H11405

DESCRIPTIVE REPORT

General Locality Ernest Sound and Eastern Passage

Descriptive Report to Accompany Hydrographic Survey H11405

Figure 3.1.1

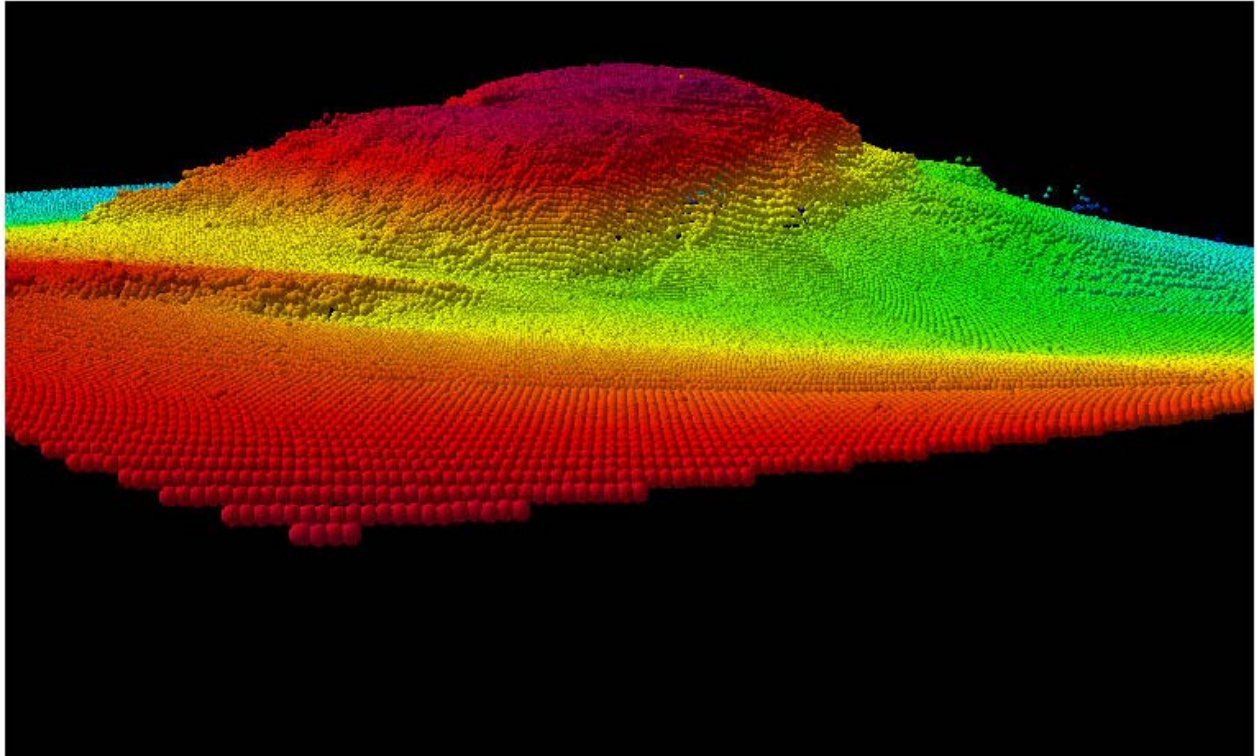
Shoal sounding

Chart sounding.

Shoal sounding reported as a DTON. Chart 17385 has been updated with new sounding. However, after reviewing the BASE surface, it was determined that the sounding is a rock and will be compiled to the HCell as a rock.

Figure 3.2.1

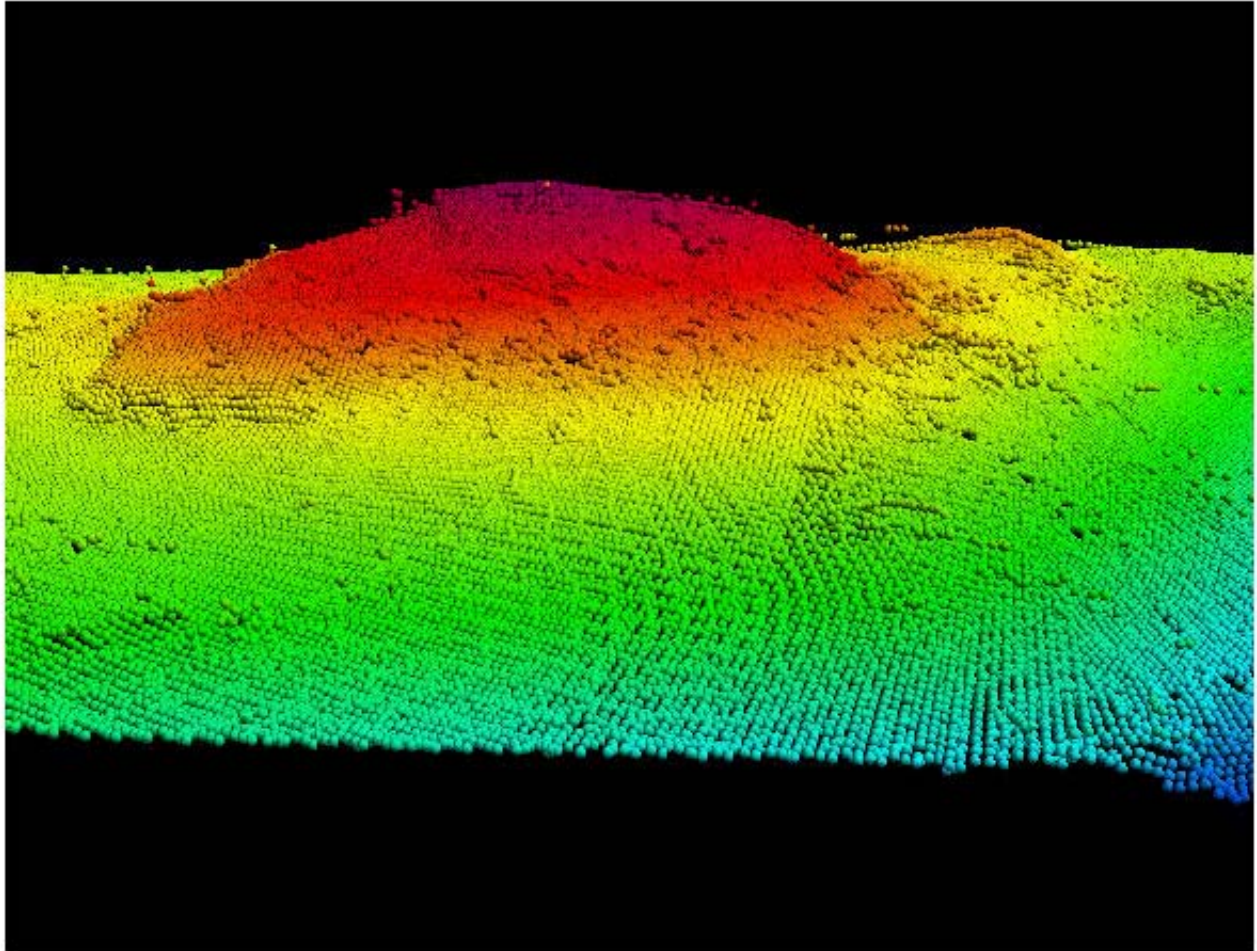
Shoal sounding

Chart sounding.

Shoal sounding reported as a DTON. Chart 17385 has been updated with new sounding. However, after reviewing the BASE surface, it was determined that the sounding is a rock and will be compiled to the HCell as a rock.
